Appendix I of RNTPC  
Paper No. A/YL-KTN/1130

# **Proposed Temporary Open Storage and Warehouse for Storage of Construction Machinery and Construction Materials for a Period of 3 Years**

**Lot 1560 (Part) in D.D. 107, Kam Tin, Yuen Long, New Territories**

**Proposed Temporary Open Storage and Warehouse for Storage of Construction Machinery and Construction Materials for a Period of 3 Years at Lot 1560 (Part) in D.D. 107, Kam Tin, Yuen Long, New Territories**

Proposed Layout Plan

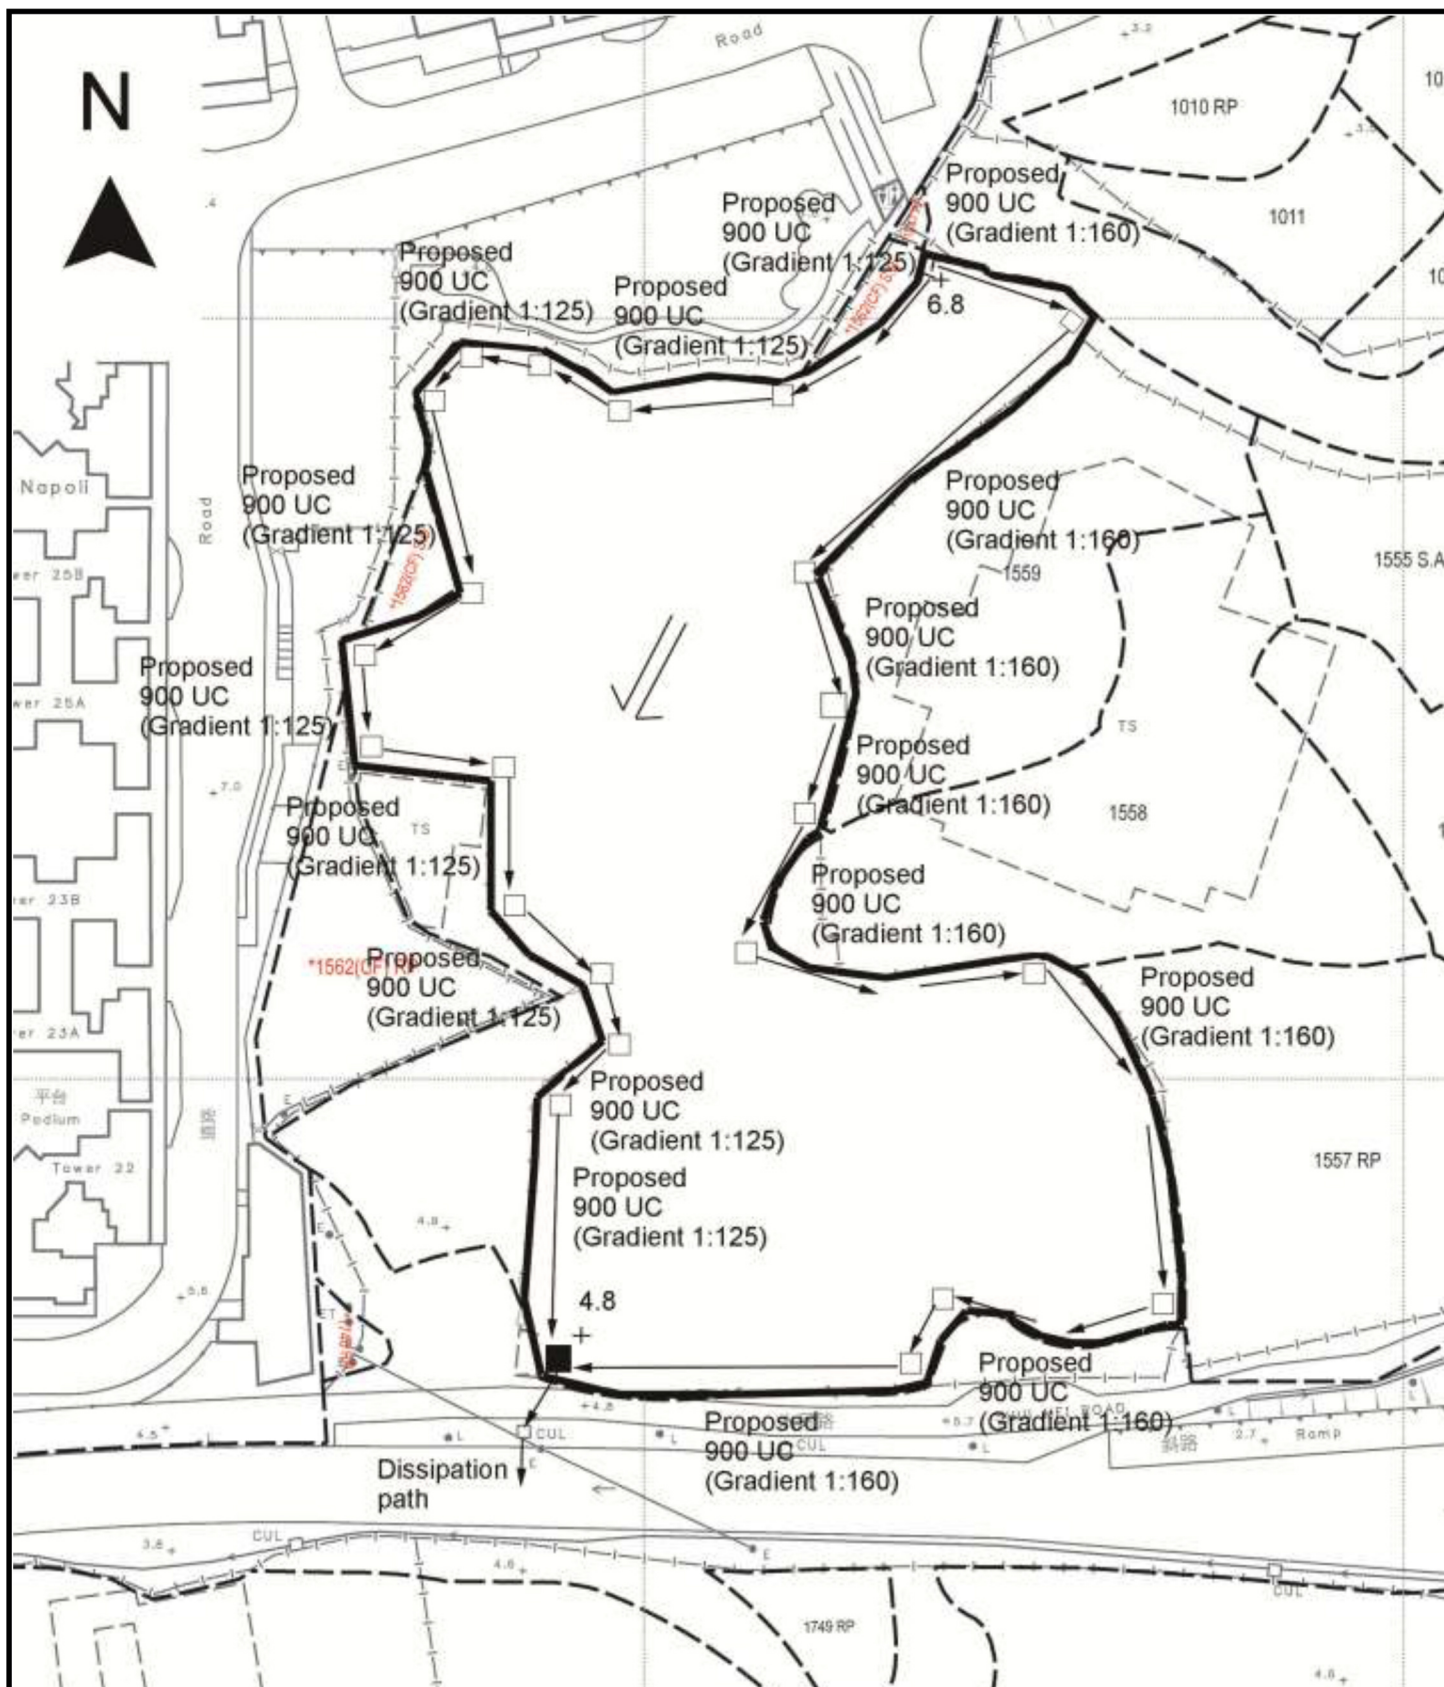
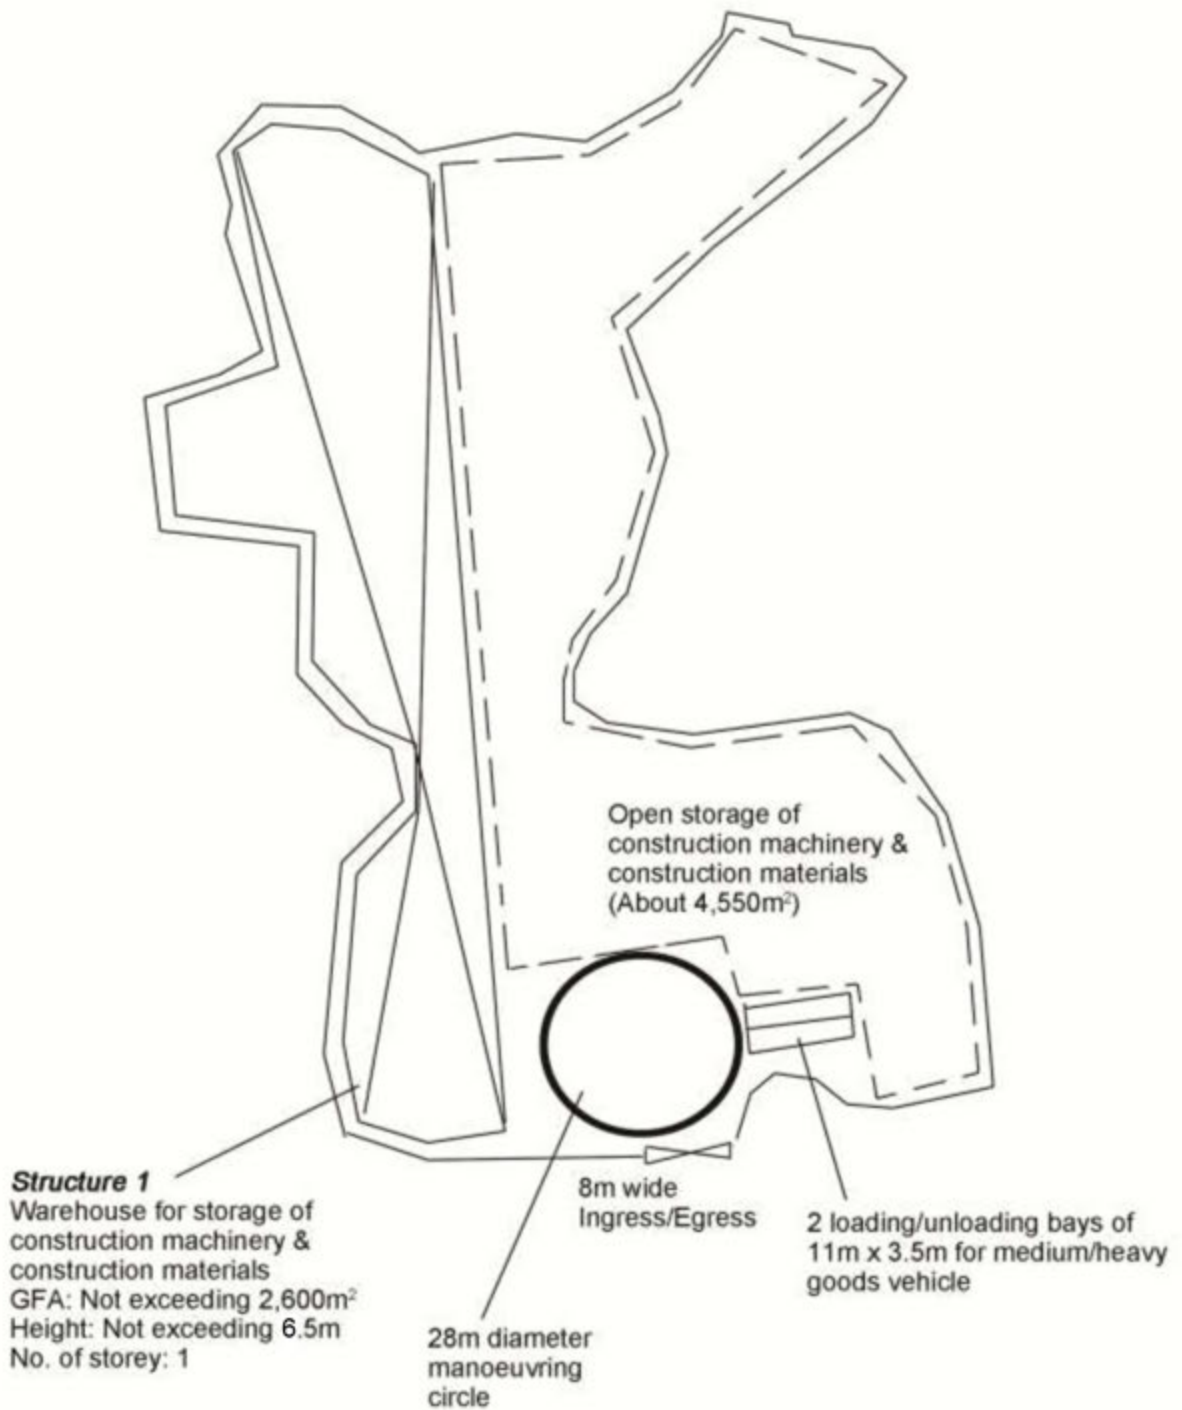
Building Department's comments	Applicant's response
The headroom of the proposed structure of 8.5m is considered excessive.	Noted. The applicant propose to reduce the headroom of the proposed structure to 6.5m as shown in the updated layout plan (Figure 3) and updated page 5 and 11 of S.16-III application form.

The applicant will demolish the temporary structures at the application site and apply for the short term waiver (STW) for the proposed structure as shown in the proposed

layout plan (Figure 3).
